**Re: Wyatt Drive – Proposed Condominium
Sketch Plan Review of Alternatives**

From: Daniel Diffin <dpd@smemaine.com>
Sent: Thursday, August 11, 2022 2:13 PM
To: Carla Nixon <cnixon@cumberlandmaine.com>
Cc: Tom Farmer <tsffarmer@gmail.com>
Subject: RE: Wyatt Drive Subdivision digital submission

Please see below for some initial comments on the Sketch Plan Submission for the Wyatt Drive Subdivision:

WYATT DRIVE SUBDIVISION
CLUSTERED DUPLEX CONDOMINIUM

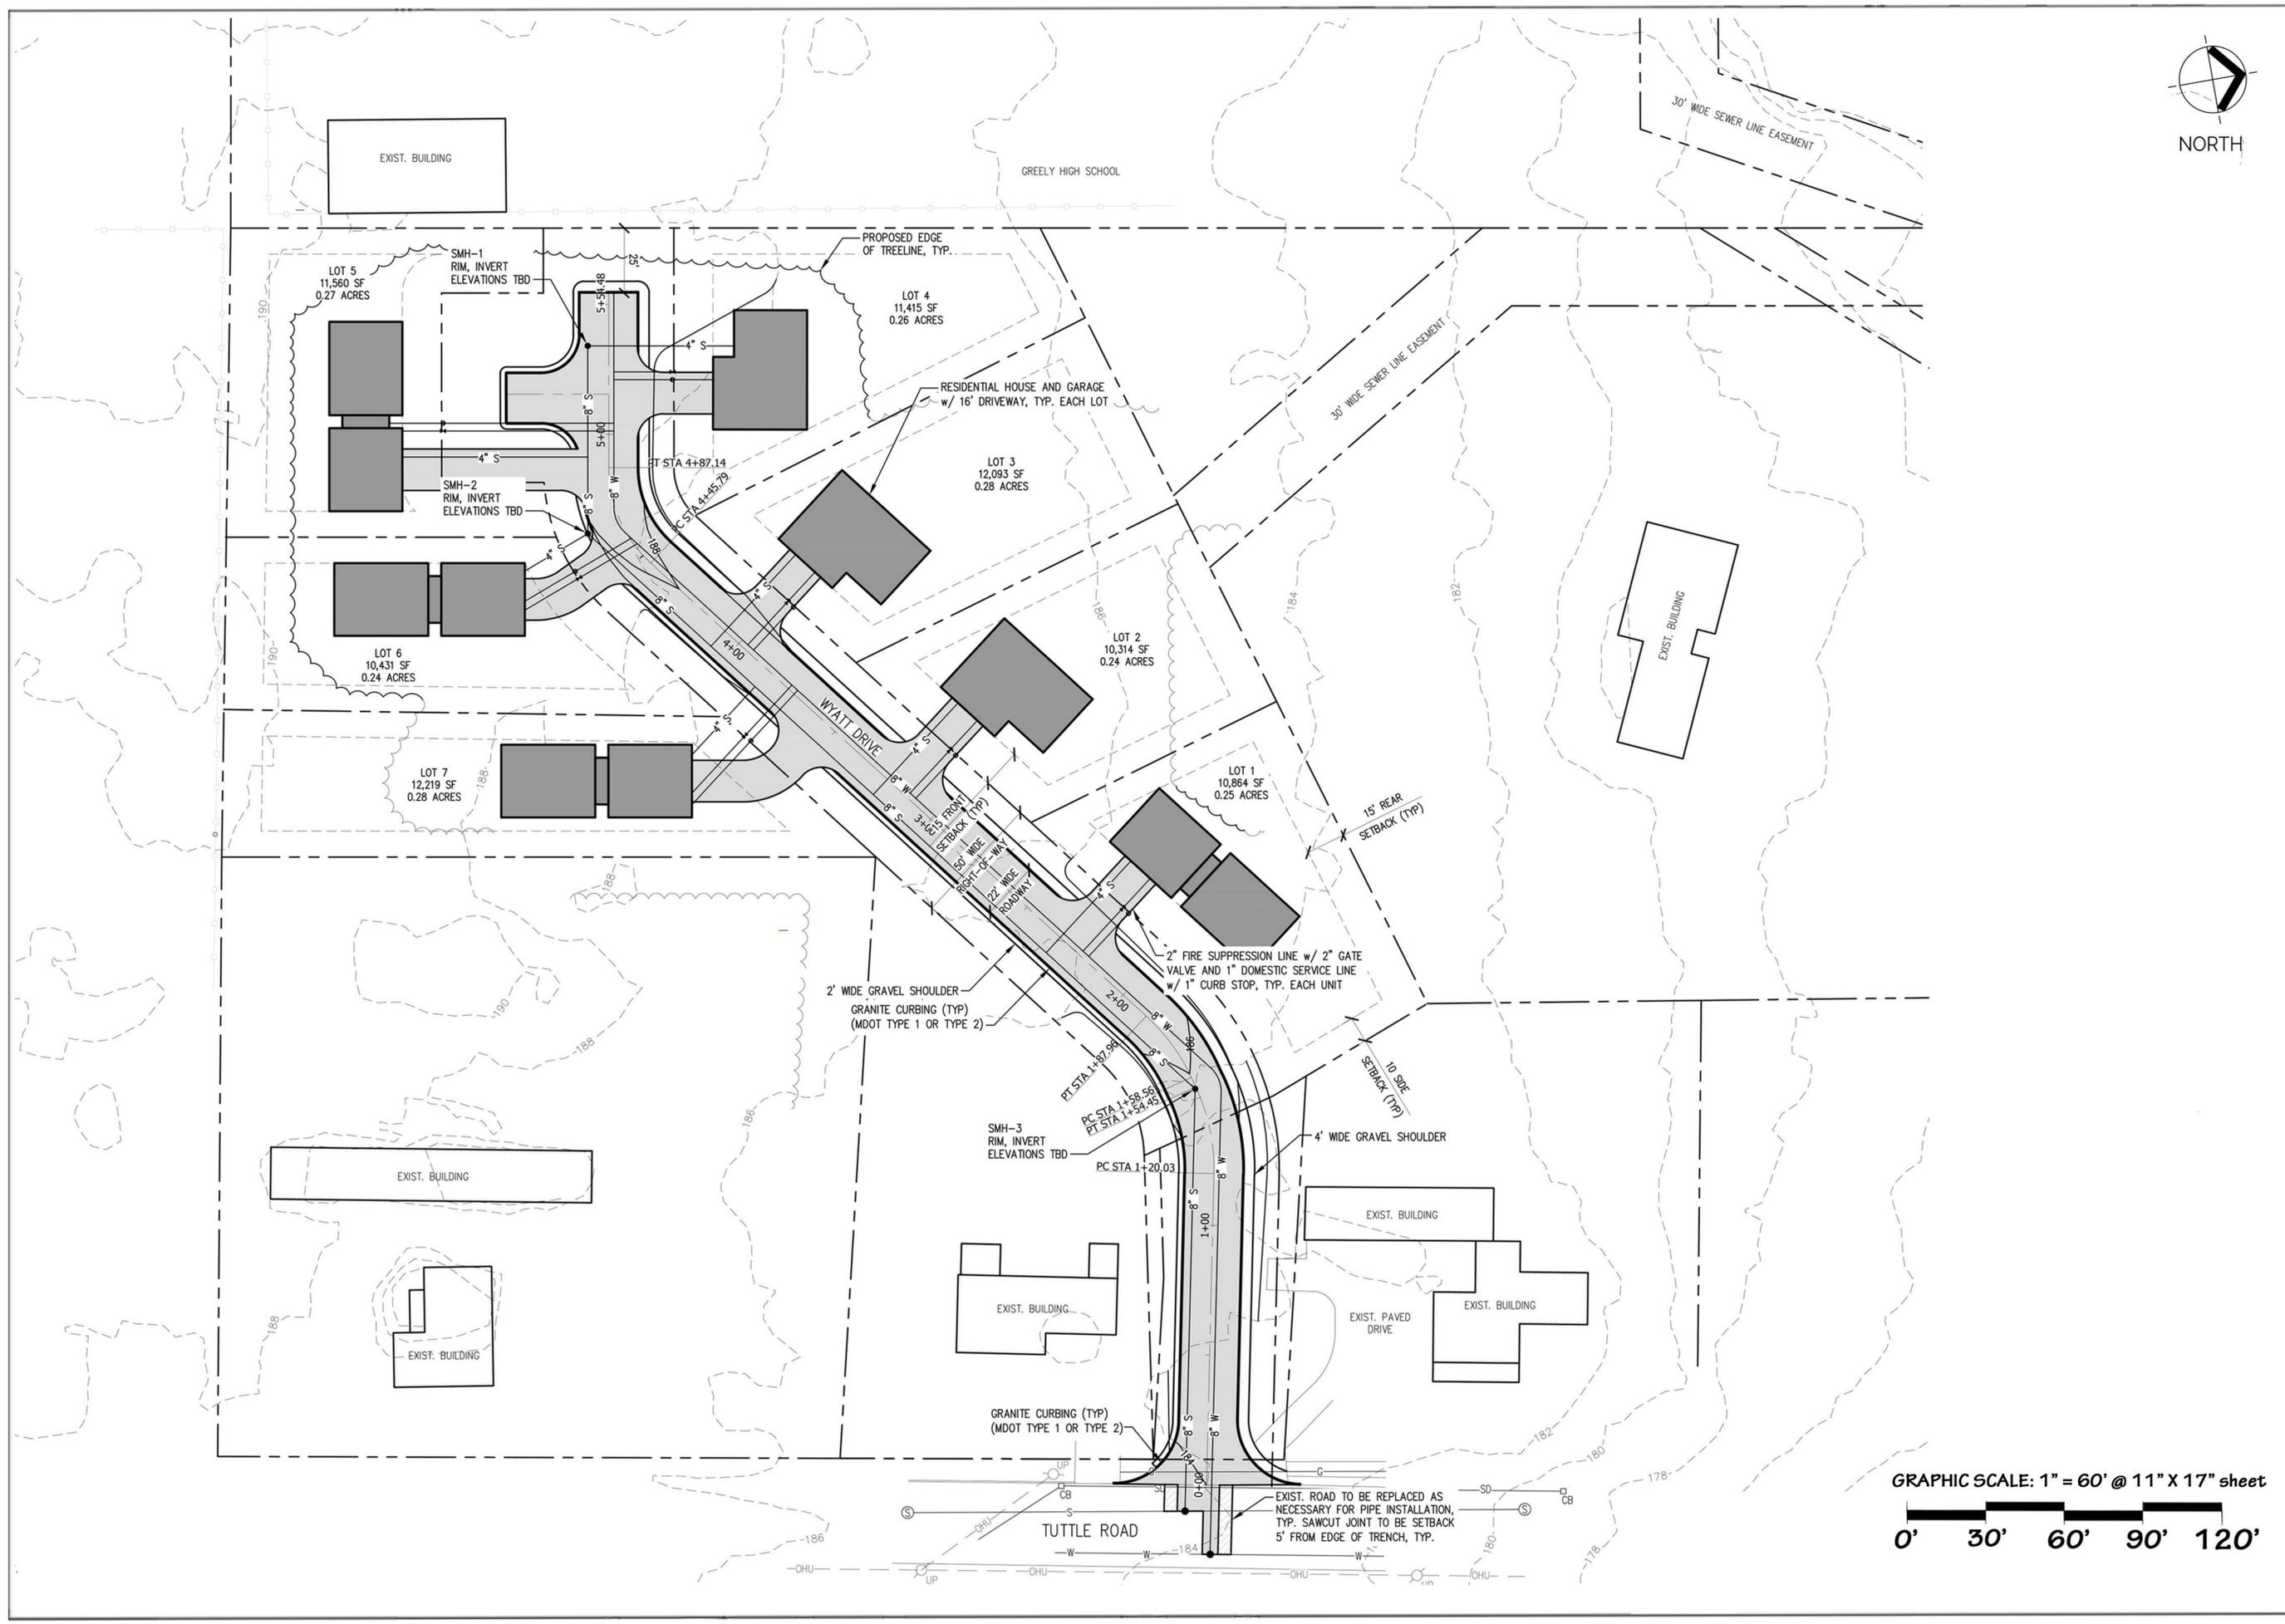
1. We have reviewed the waiver requests and find the following:
 - a. 75' Perimeter Buffer – SME recommends approval of this waiver.
 - b. Road Width – With the proposed 18-units, the projected vehicles per day would be 144 per Table 1 of Section 250-37 of the Subdivision Ordinance, which is well above the maximum 50 trips per day limit for Private Street Standards. As noted in the Cover Letter provided, this level of use would classify the subdivision street as a Residential Access Street with a required width of 22-feet of pavement with additional 2-foot shoulders on each side. SME recommends that the Applicant provide further information as to why a 22-foot-wide section would not work on this site prior to further consideration of this waiver request. With that, SME recommends a detailed analysis of the required turning maneuvers for emergency vehicles to demonstrate that the proposed road design is adequate.

- c. High-Intensity Soil Survey – SME recommends approval of this waiver.
2. The Net Residential Acreage Calculation should be adjusted based on the final width of the roadway.

3. We recommend that the Applicant confirm the sewer main elevations in Tuttle Road early in the design process. In recent Town projects, it was found that this line was generally shallow, and the Applicant may need to consider connecting with the existing sewer easement to the north of the project site.

4. We recommend that the Applicant coordinate with the homeowner directly north of the intersection with Tuttle Road. It appears that a portion of the abutter's driveway is on the property required for the connection to Tuttle Road.
